**CITY OF ESSEX JUNCTION  
DEVELOPMENT REVIEW BOARD  
PUBLIC HEARING AGENDA  
MARCH 21, 2024  
6:30 P.M.**

**To:** Development Review Board  
**From:** Jennifer Marbl  
**Date:** 03/13/2024  
**Subject:** 4 Church Street – Final Site Plan Review for converting a duplex into a triplex  
**File:** SP# 1.2024.1

**To:** Development Review Board  
**From:** Jennifer Marbl  
**Date:** 03/12/2024  
**Subject:** Riverside in the Village - 5 Fuller Place – Conceptual Site Plan Review for demolition of an existing building and construction of a 32-unit residential apartment building  
**File:** SP# 1.2001.48

# FIRST FLOOR Apt 1 Proposed \*

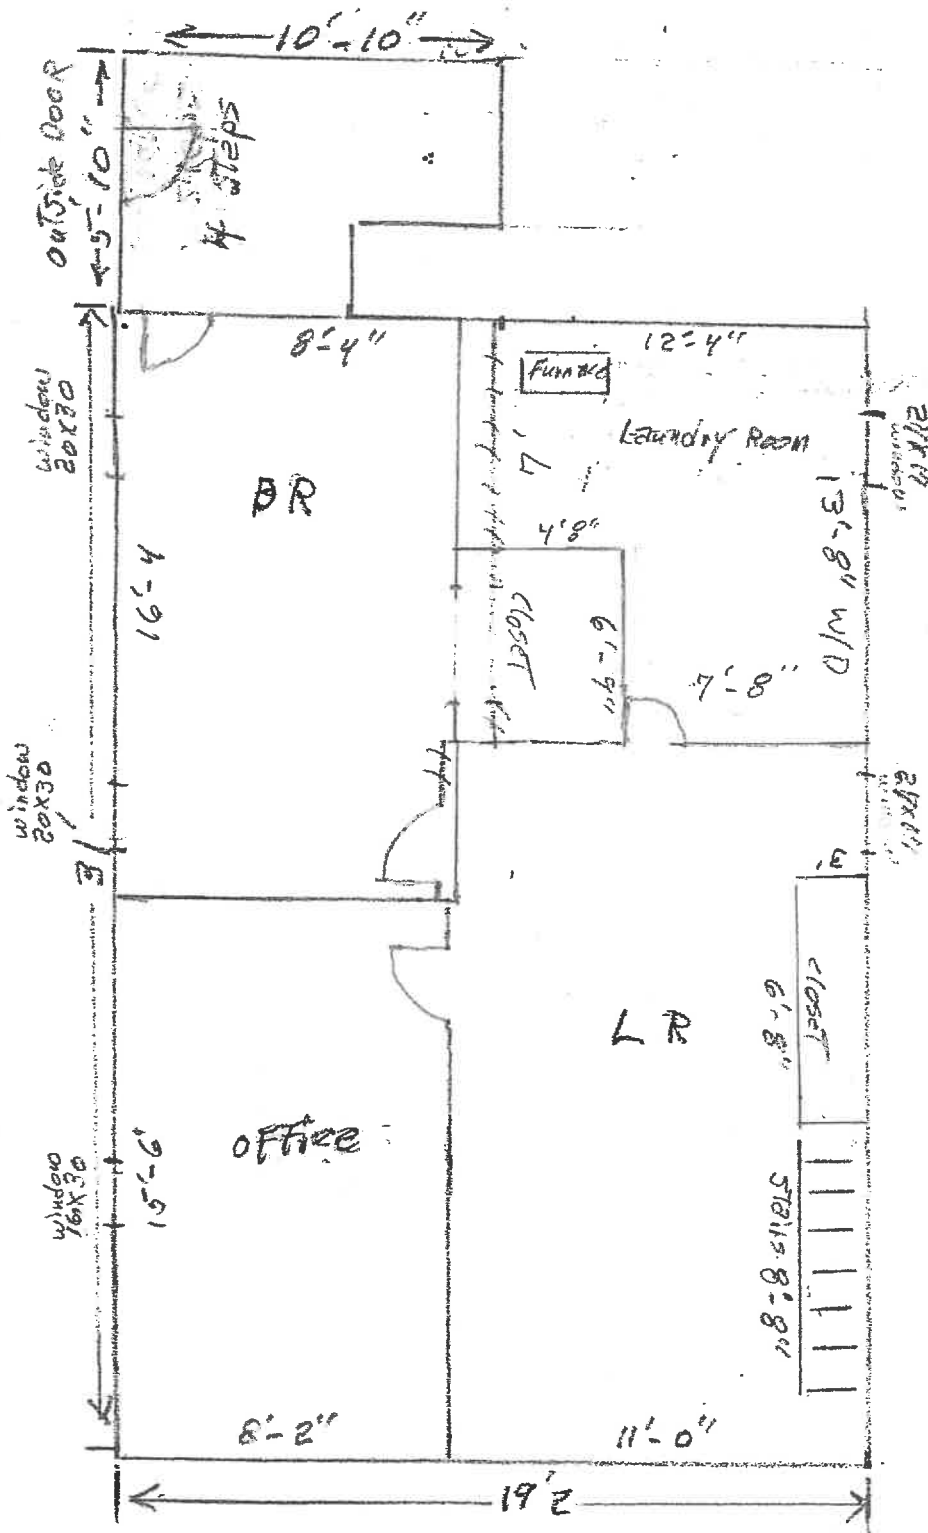
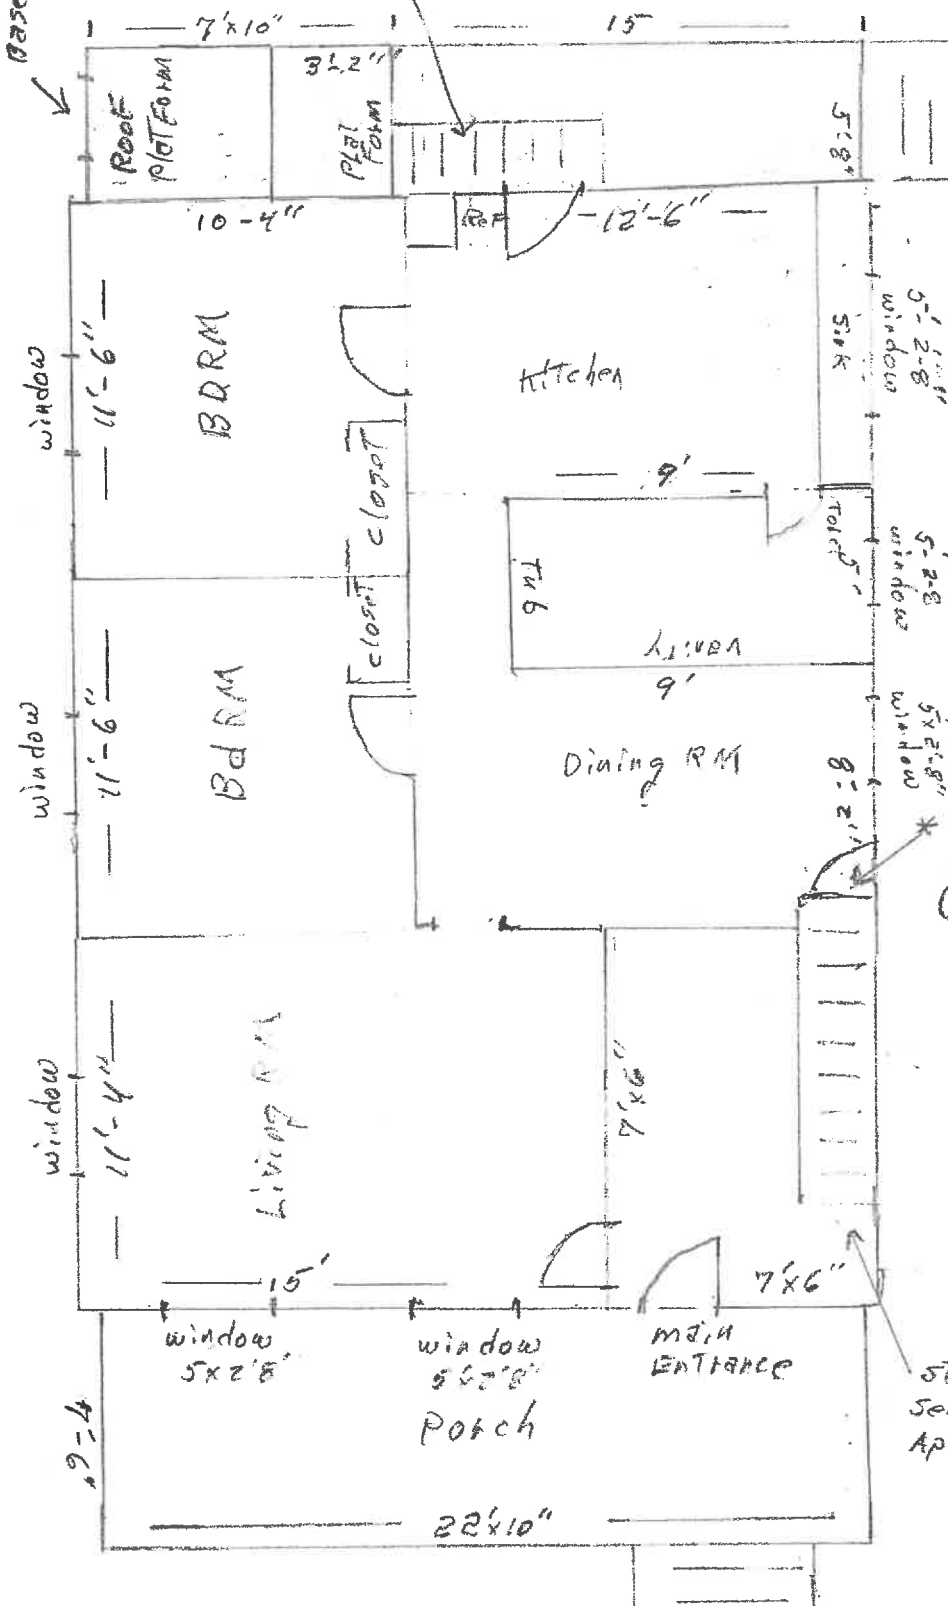
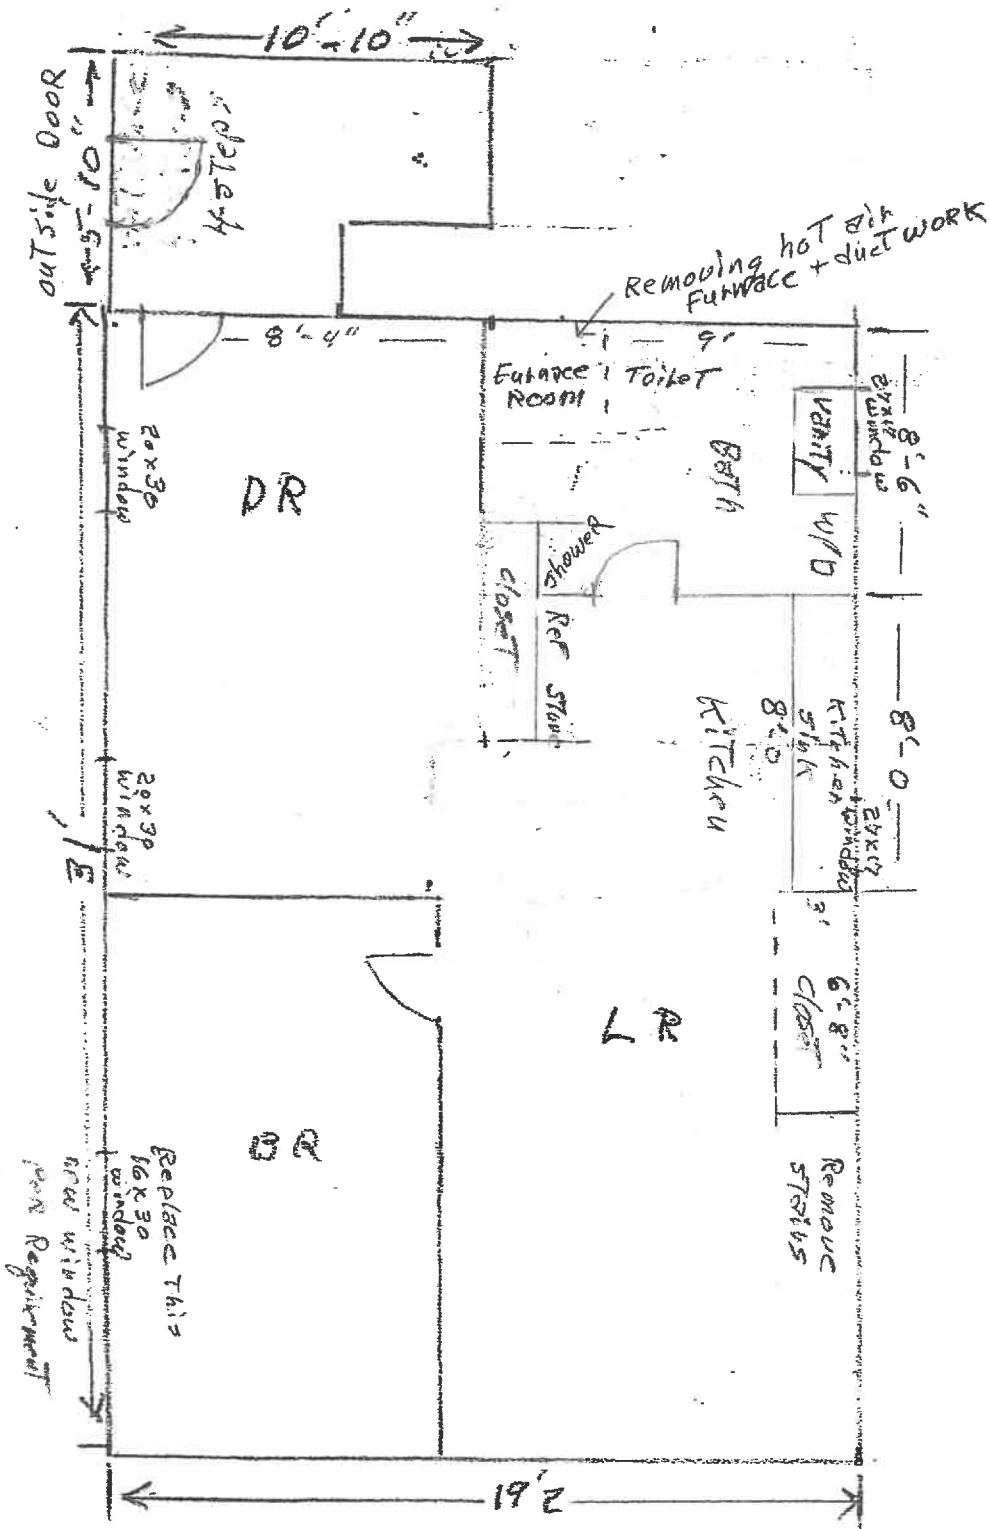
There have been minor changes to the floor plan, regarding laundry rooms, closets, and related supporting utilities. Beyond this, nothing impacting zoning requirements has changed between this review and the previous, preliminary review on February 15<sup>th</sup>, 2024.

2-27-24 From conceptual approval, I am removing the stairs going to basement and making a closet above the stairs.

IN The Basement, I am removing the Furnace (hot air) and duct work, per submitted plans.

Riverside in the Village  
5 FULLER PLACE - ESSEX JUNCTION, VT  
OVERALL SITE PLAN

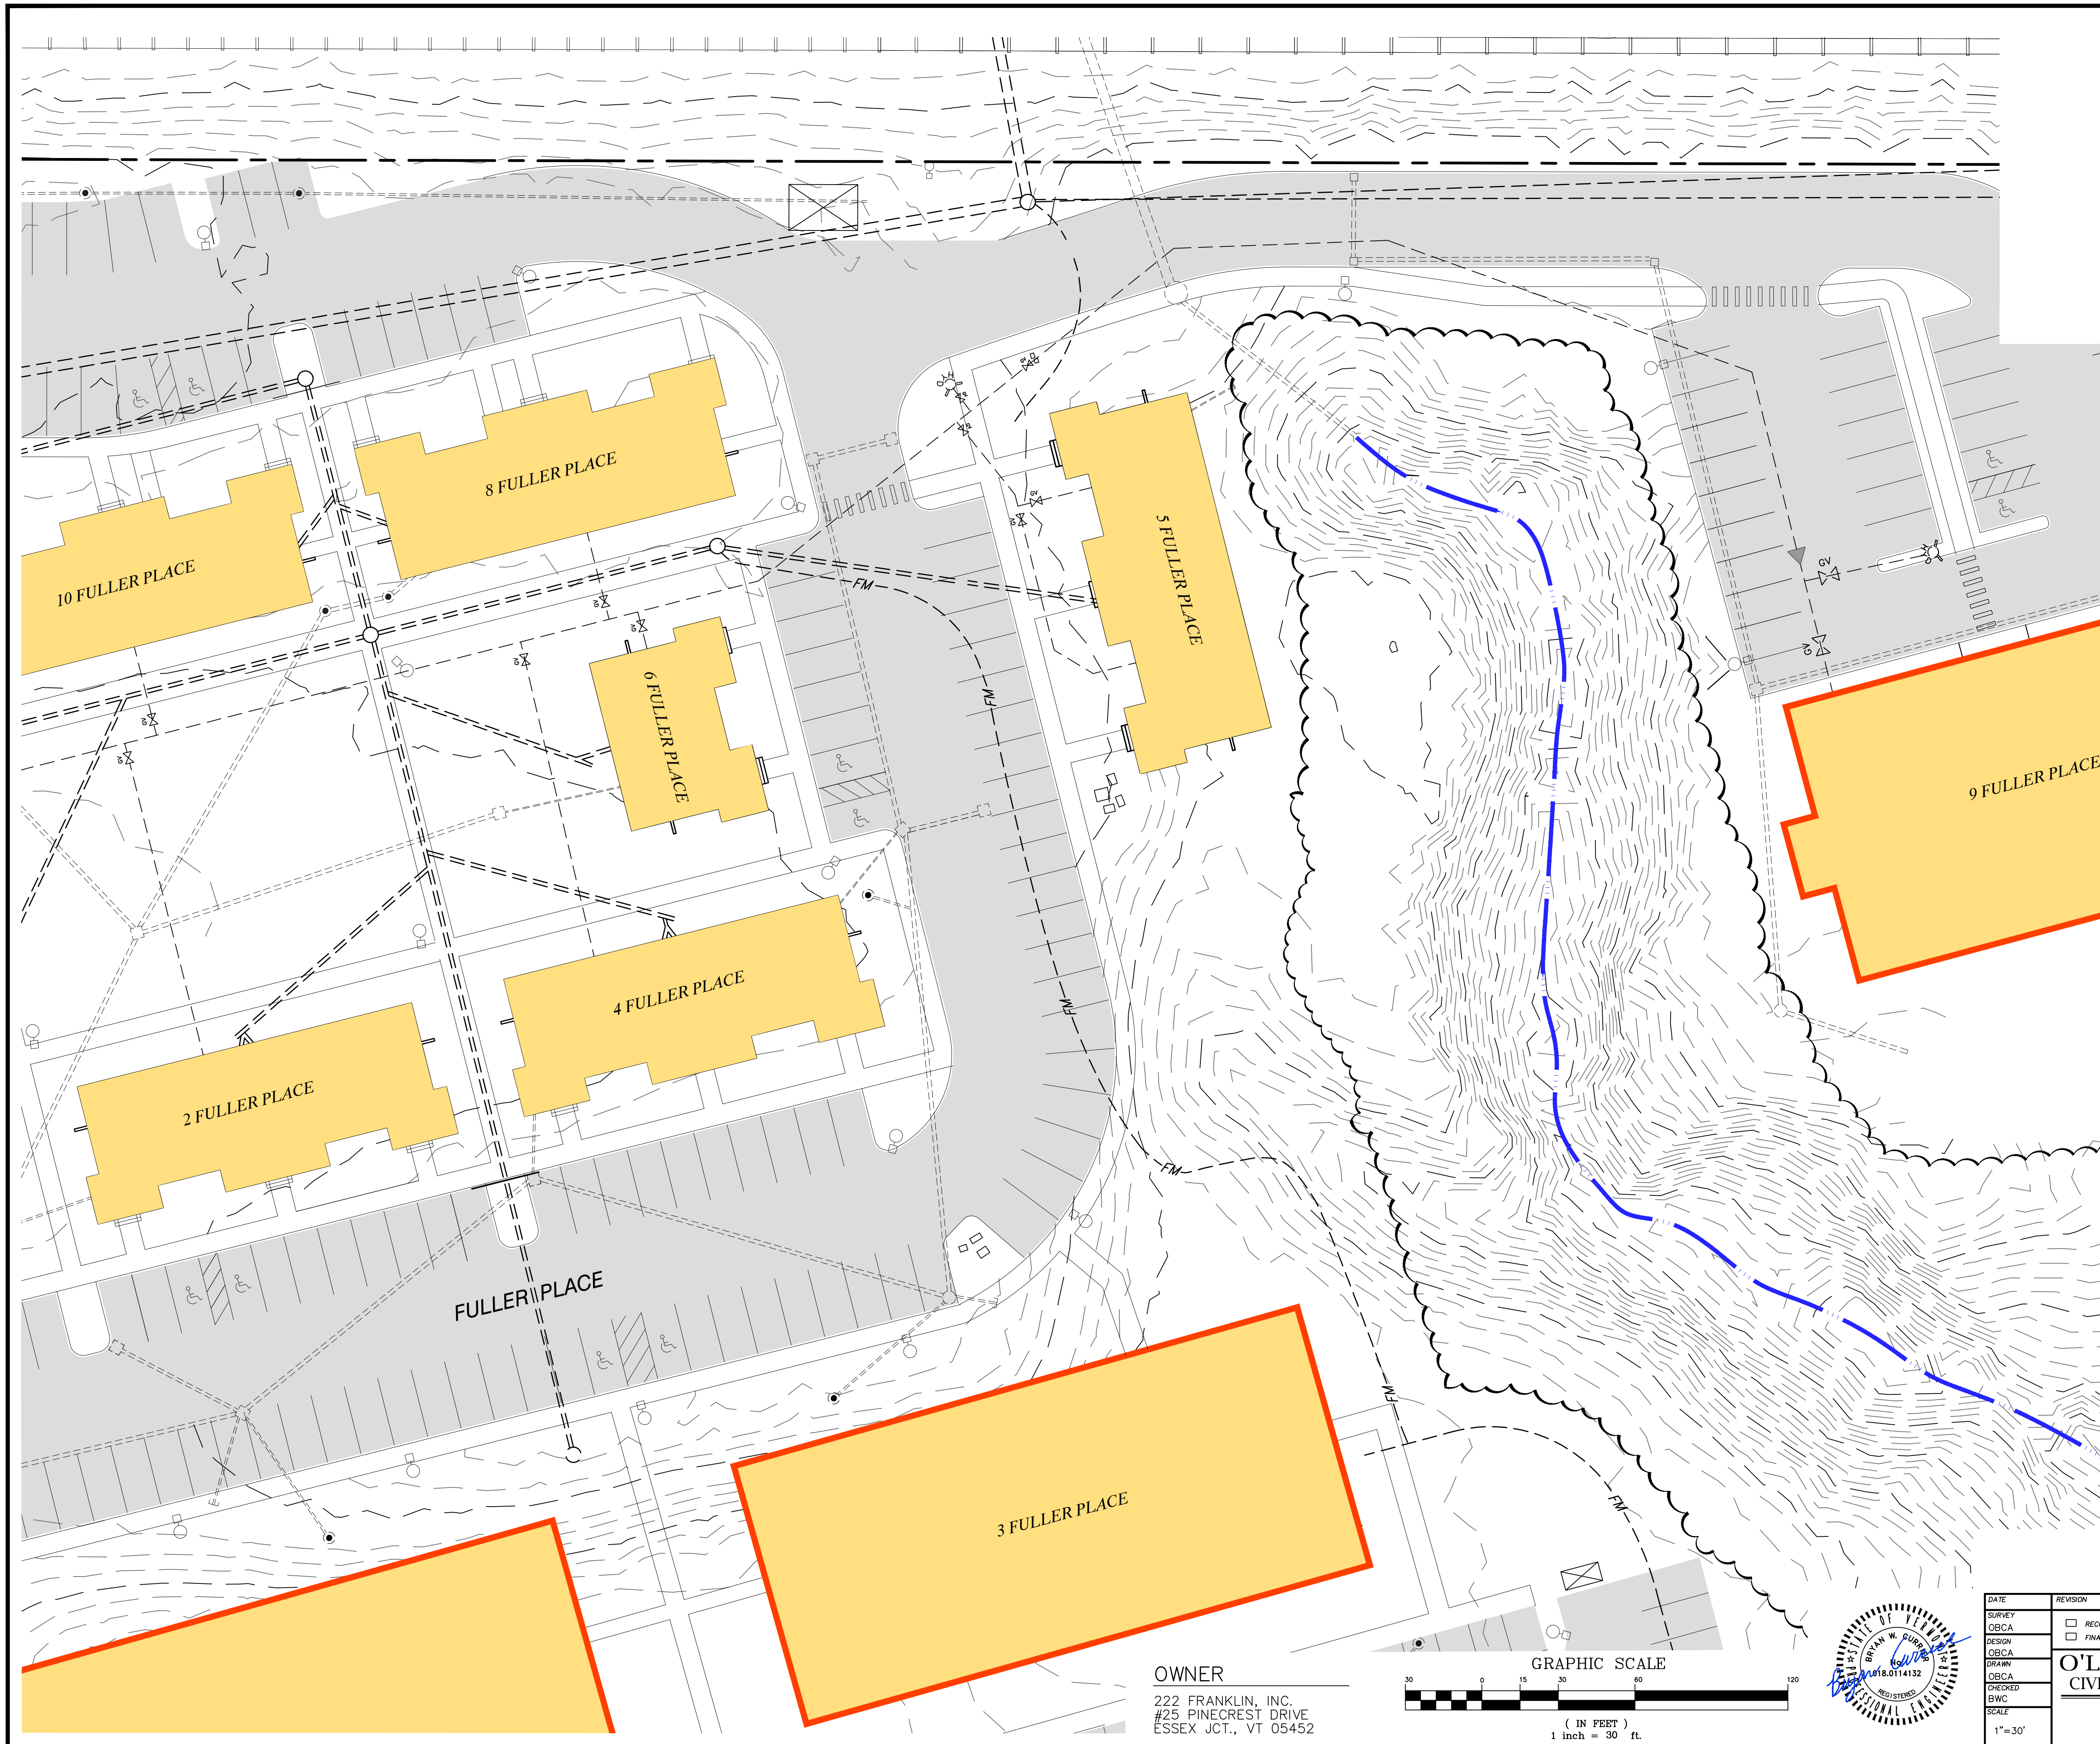
The proposed development is within 200 ft of a waterway, floodplain or wetland, and is therefore subject to the requirements of Section 516. Plans with sufficient details on the project's impact on the adjacent stream have not been submitted as a part of the conceptual site plan application. A full engineering review will be conducted at the time of final site application.

The final site plan application should be made to indicate the distance from the proposed structures and construction activity to nearby waterways, floodplain or wetland and the percent slope of the proposed site.

Section 516.H includes standards to promote the establishment and protection of heavily vegetated areas of native vegetation and trees along waterways to reduce the impact of stormwater runoff, prevent soil erosion, protect wildlife, fish habitat and maintain water quality. The proposed buildings and new driveways appear to be within or in close proximity of the

riparian buffer of a waterway. The final site plan will be required to include details to demonstrate compliance with these standards.
